## Certificate of Appropriateness Application

**ADDRESS OF SUBJECT PROPERTY:** 308 N Waddill St.

# "AS BUILT" ELEVATIONS

REVISION RECORD			
DATE	REV	ORIGINATOR	REVISION
6/14	1	OWNER	ADD DISPLAY NICHE
6/22	2	OWNER	CHG. NICHE, MBR DOOR, FRONT PORCH, ADD & MOVE D.R. WINDOWS
8/22	3	OWNER	MOVE PORCH / DINING RM. WALL, CORRECT SQUARE FOOTAGE.
10/5	4	OWNER	LOWER ROOF LINE, PER CITY REVIEW
1/15/20	5	CON/OWN	ROOF CHANGES, MISC. INT. CHGS.
11/10/21	6	OWNER	FURNISH "AS BUILT" ELEV. FOR HIST. COMM. WITH EXPLANATIONS.

1 WEST ELEVATION (FRONT)  
1/4" = 1'-0"

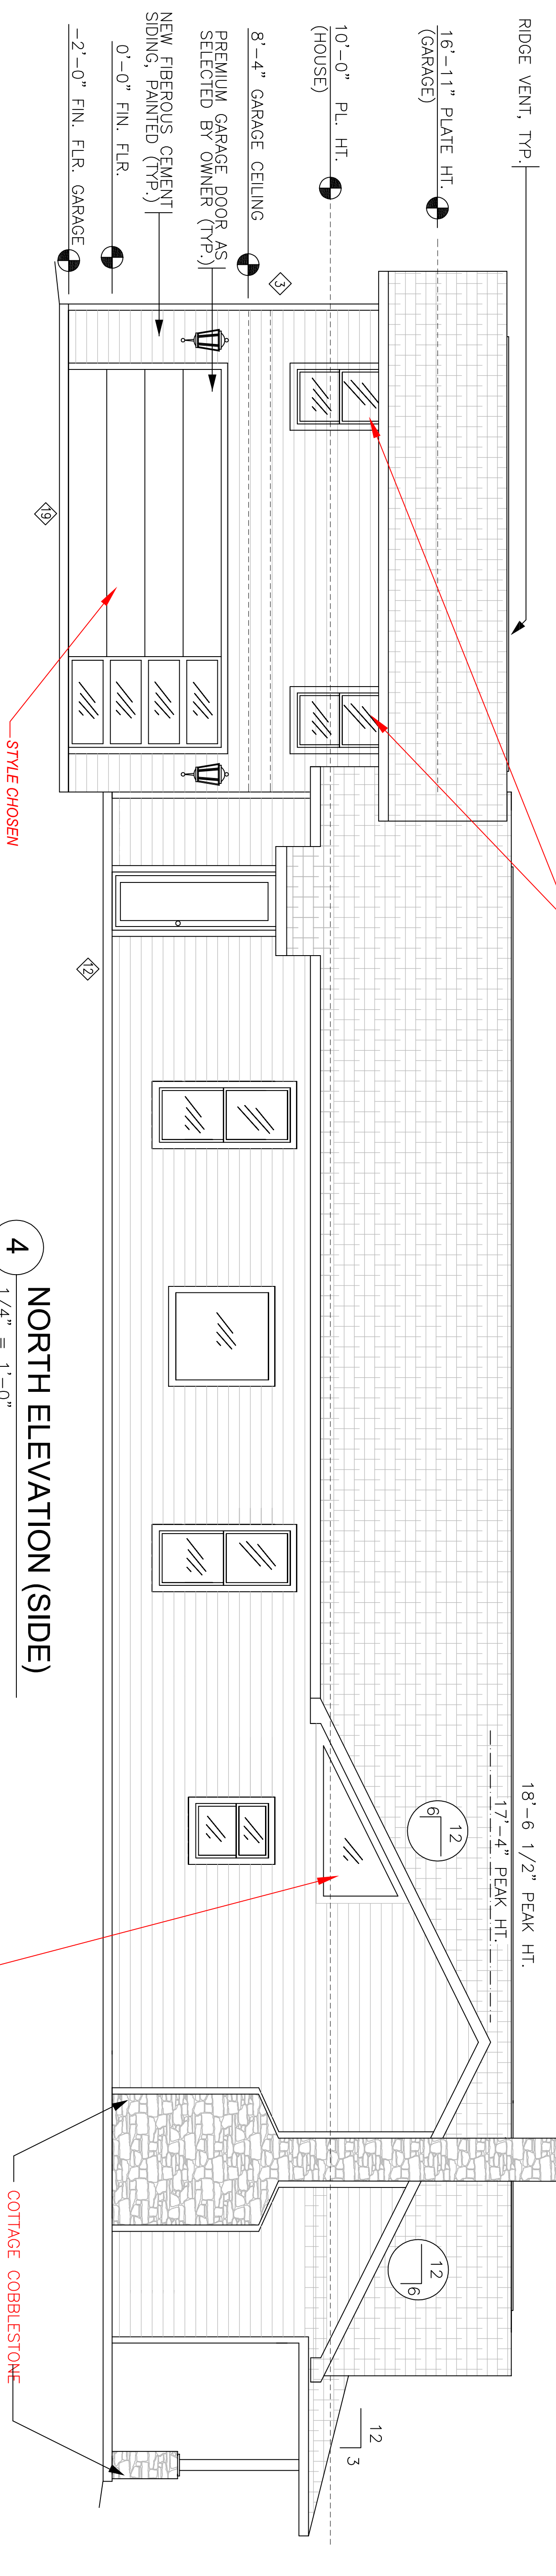
ROOF PEAKS CHANGED SLIGHTLY BECAUSE ROOF PITCHES CHANGED AFTER DISCUSSION WITH FRAMERS AS TO BEST WAY TO THE INTO REAR PART OF HOUSE SINCE IT WAS NOW ON A SLAB INSTEAD OF CRAWL SPACE (ALSO PER CITY REVIEW AND REQUEST OCT. 2019).

NOTE: STONE CARRIED INTO GABLE - FIRST, THE STONE IS A FAUX STONE APPROXIMATELY 1/2 THE WEIGHT OF STANDARD STONE. THIS WAS USED TO MATCH THE STONE USED ON THE HOUSE FRONT AND ON THE COLUMNS. ALSO THE FRAMERS ADDED ADDITIONAL SUPPORT FRAMING TO THE GABLE FOR ADDED STRENGTH.

6" X 6" CEDAR WOOD COLUMN OVER 12" SQ. COTTAGE COBBLESTONE (TYP.)  
CHANGED: 6" SQUARE COLUMN OVER 15" SQUARE STONE BASE (TYP. - ALL) LOOKS BETTER AND OFFERS MORE SUPPORT.

WINDOWS MATCH WHAT WERE PREVIOUSLY APPROVED BY THE CITY, EXCEPT A LITTLE LONGER.

STONE FRONT ADDED TO GIVE THE HOUSE MORE OF AN OLD WORLD HISTORICAL LOOK. (THERE IS A HOUSE ONE BLOCK AWAY WITH STONE ALL THE WAY TO THE PEAK OF THE HOUSE)

WINDOWS MOVED SLIGHTLY AND SHORTENED SLIGHTLY TO BETTER ACCOMMODATE THE DINING ROOM INTERIOR. THERE IS NO IMPACT AT ALL ON THE LOOKS OF THE PORCH.

CITY APPROVED FRONT DOOR WITH SIDELIGHTS. I CHANGED TO DOUBLE FRONT DOORS, WITH GLASS BUT NO SIDELIGHTS, AND MORE SECURE.

NO RAISED PORCH - CONTRACTOR EXPLAINED THAT DUE TO GRADE SLOPE TO REAR, BACK OF HOUSE WOULD BE OVER 5' OFF THE GROUND. WE DECIDED TO DO A SLAB ON GRADE RATHER THAN CRAWL SPACE. ALSO, TOOK OFF PORCH RAILING, SINCE THERE WAS NO RAISED PORCH.
